PROPOSED DRAFT GLOBAL TECHNICAL REGULATION (GTR)  
on  
PEDESTRIAN PROTECTION.

This document is a working document circulated for discussion and comments. It is only submitted with the intention to facilitate discussion by the GRSP Informal Group.

GLOBAL TECHNICAL REGULATION NO. Y

UNIFORM PROVISIONS CONCERNING THE APPROVAL OF VEHICLES WITH REGARD TO  
THEIR CONSTRUCTION IN ORDER TO IMPROVE THE PROTECTION AND MITIGATE THE  
SEVERITY OF INJURIES TO PEDESTRIANS AND OTHER VULNERABLE ROAD USERS IN  
THE EVENT OF A COLLISION

Figure 6: Impact Point. (*insertion of impact angle example*)

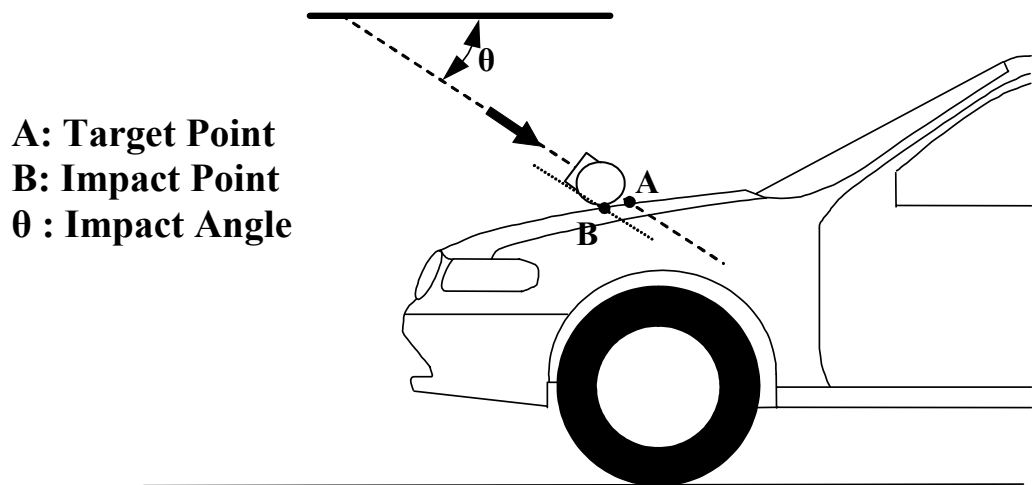
*Figure 6 could be used to provide an example of the measured angle.*

Figure 13c: Windscreen Lower Reference Line  
*This diagram requires more discussion and agreement.*

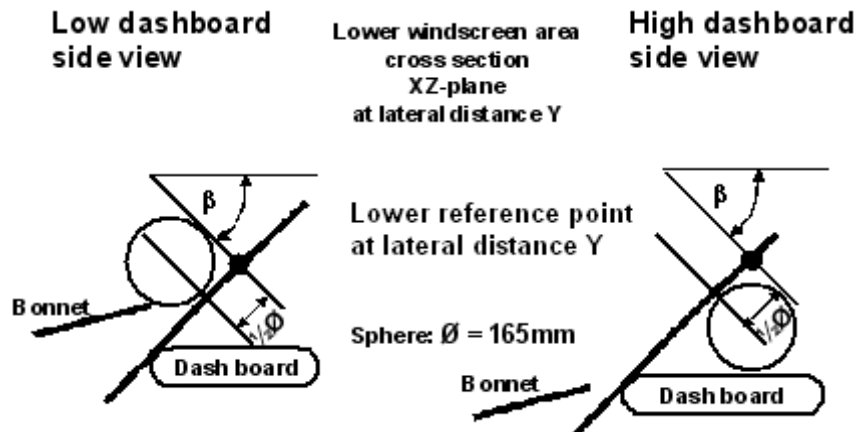
TO BE DEFINED, see Figure 13c.
